PIC18F87J50 FAMILY

PIC18F87J50 Family Silicon Errata and Data Sheet Clarification

FIGURE 19-10: I²C™ SLAVE MODE TIMING (TRANSMISSION, 7-BIT ADDRESS)

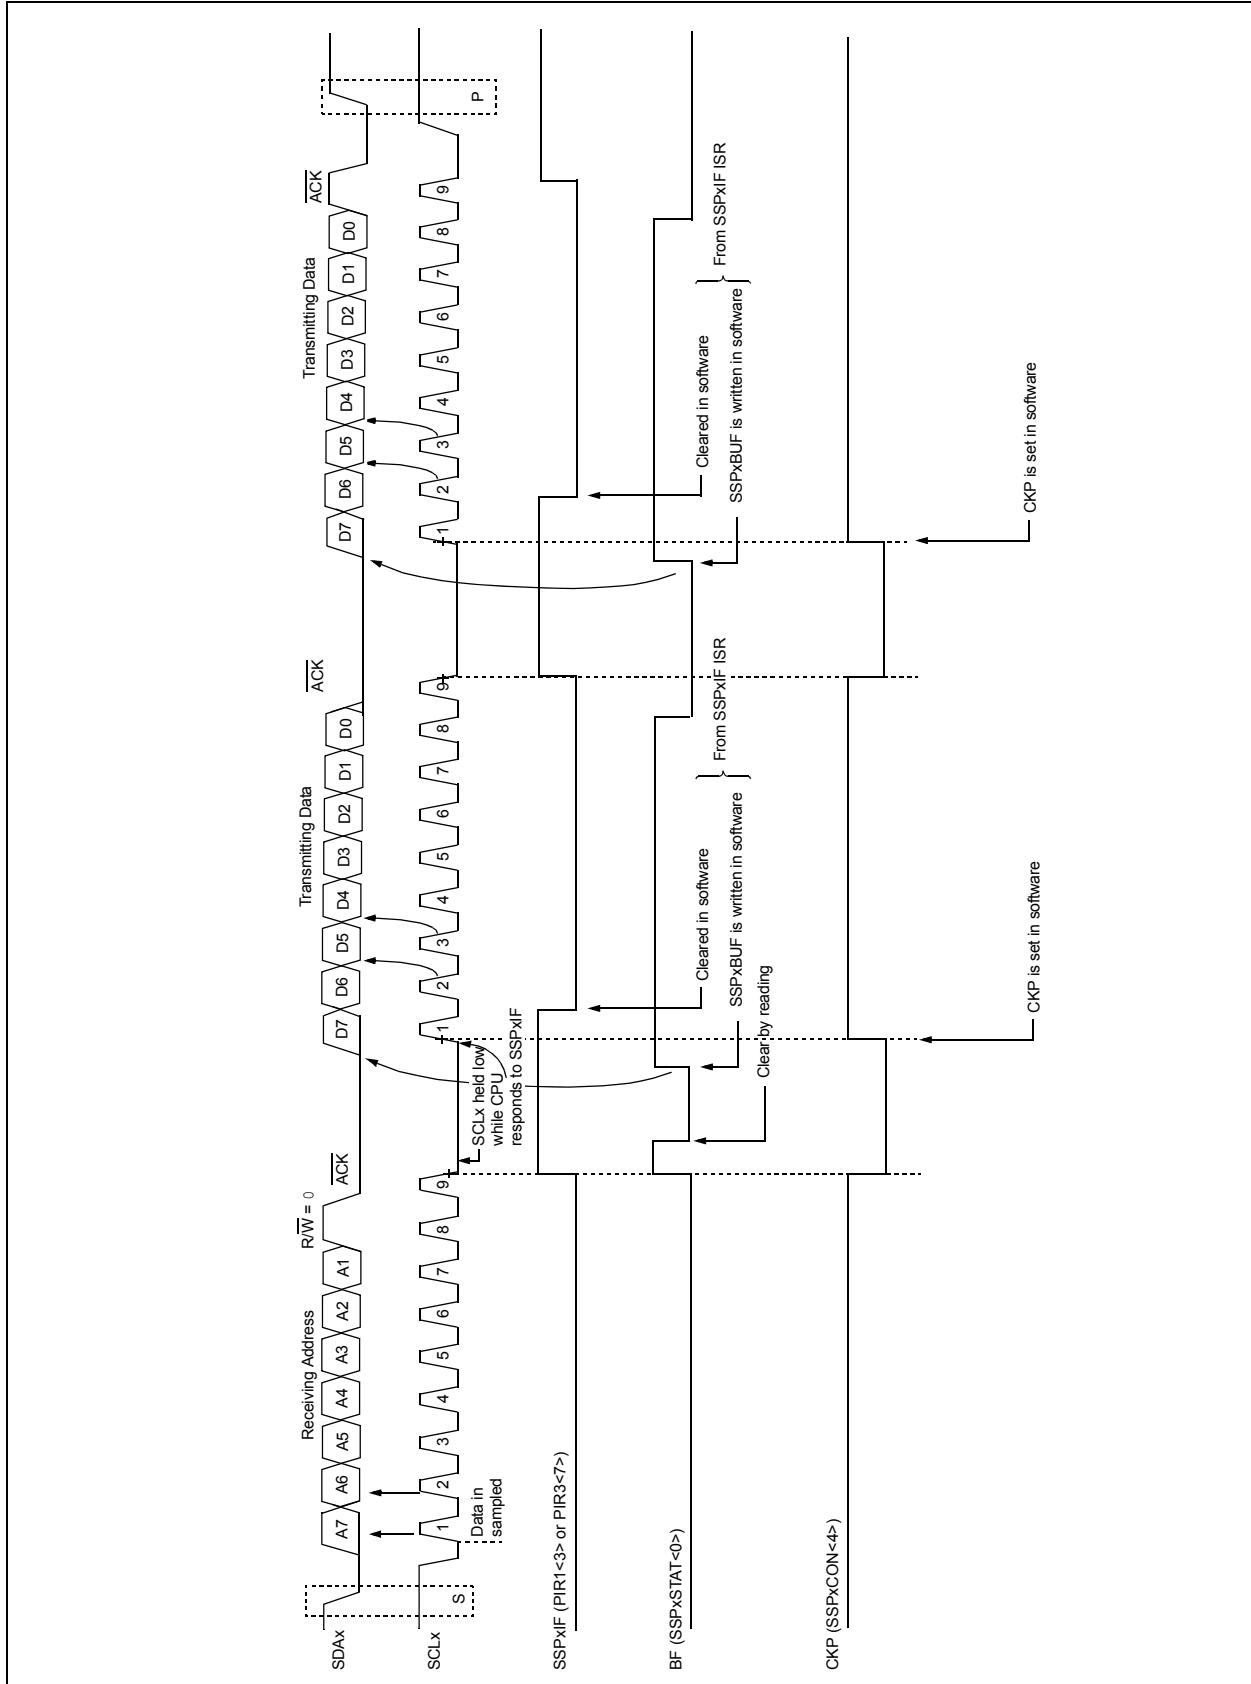
6. Module: Figure 19-10: I²C™ Slave Mode Timing (Transmission, 7-Bit Address)

On page 252, the figure is replaced with the new timing diagram provided in Figure 19-10.

FIGURE 19-24: I²C™ MASTER MODE WAVEFORM (RECEPTION, 7-BIT ADDRESS)

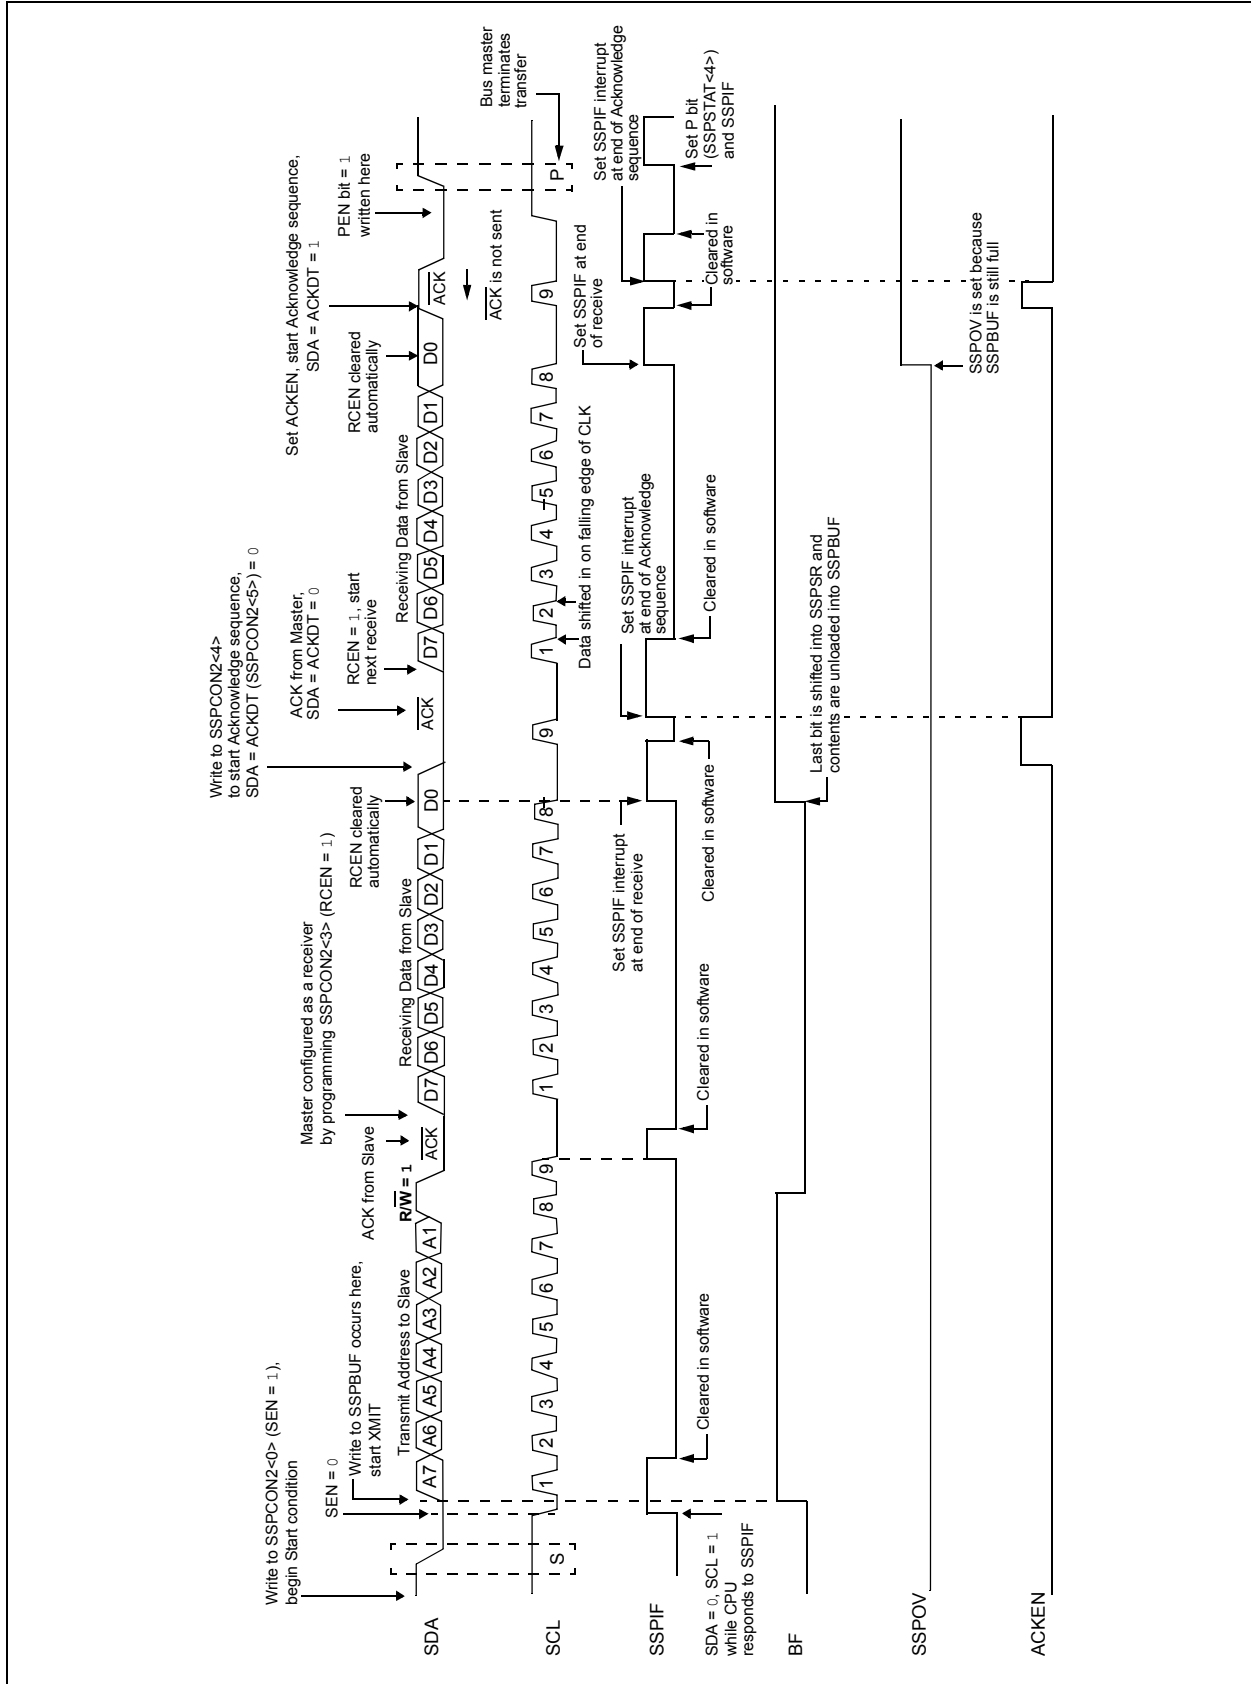
7. Module: **Figure 19-24: I²C™ Master Mode Waveform (Reception, 7-Bit Address)**

On page 269, the condition, R/\overline{W} , when the Acknowledge signal (ACK) is received from the slave, after transmitting the address to the slave, is changed to '1'.

The changed value is indicated in bold text in Figure 19-24.
